Product Change Notification

PCN#: 323

Change Title: Product Height Change

Products Affected: FOX923 series

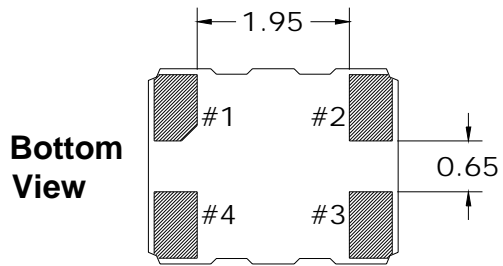
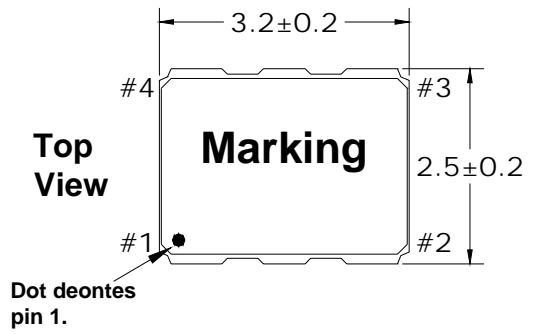
Description of Change to the Customer: In order to expand our production capacity to meet market demands and supply the highest quality product at the most reasonable costs, we are changing the standard height for the FOX923 TCXO/VCTCXO series from 1.0mm Max to 1.2mm Max. A dimensional drawing showing the old and new heights is attached.

(Product with the original, lower profiles will still be available as a special order. The lower profile package will have to be specified and a unique Fox part number configured for ordering).
